SUBJ: Resource Conservation and Recovery Act Compliance Evaluation Inspection  
Exide Technologies, LLC  
EPA ID No.: GAD 070 330 576

## RCRA Inspection Report

Re: Risk Assessment Workplan  
Notice of Deficiency

RE: Notice of Deficiency  
Phase II RFI Workplan  
EPA ID#GAD070330576

Picture 2 – Building 1 Used Oil Storage

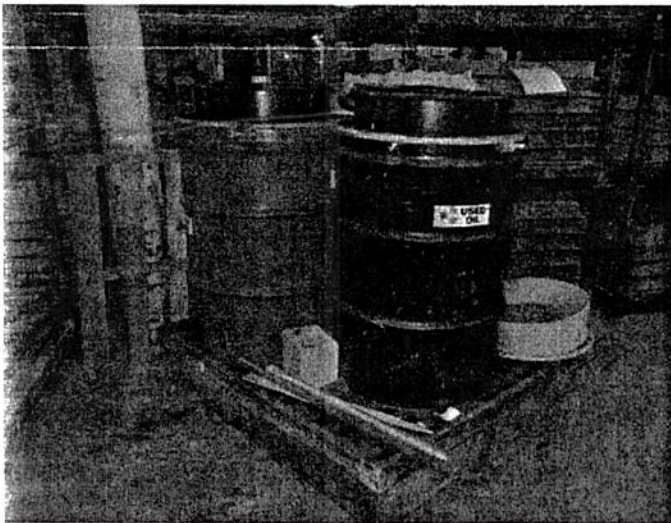
The inspection team noted several drums of labeled used oil on a secondary containment pallet (picture #2). There was some waste in the secondary containment of the pallet and the inspection team asked Exide to remove this used oil. The EPA has determined this to be an Area of Concern. Exide must determine if one of these used oil containers is leaking; Exide may be failing to respond to a used oil leak.
